BULLETIN #147

P-80

**REVISED HOUSING HOLD-DOWN CAP SCREWS
AND NUT TORQUE**

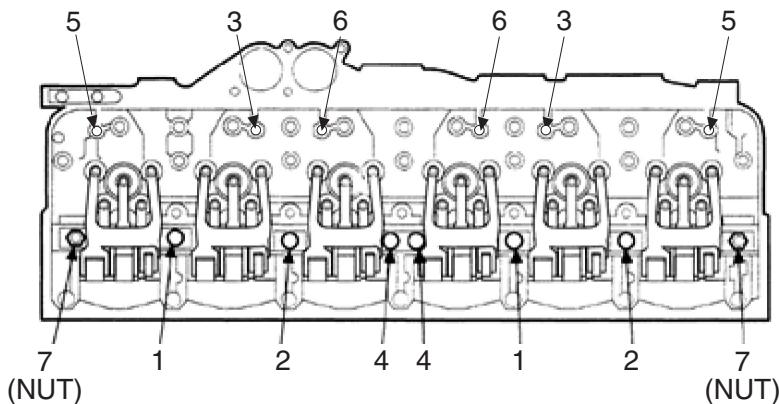
**The housing hold-down cap screw torque values have been increased to
136 N•m (100 lbs. ft.) from 101-116 N•m (75-86 lbs. ft.).**

The P-80 installation manual procedure requires torquing the cap screws in the sequence below, first to 55 N•m (40 lbs. ft.) then to 101-116 N•m (75-86 lbs. ft.) The sequence below and in the manual are correct, only the final torque has been changed (increased to 136 N•m (100 lbs. ft.)) Please make the necessary changes to any installation manuals you have for reference purposes.
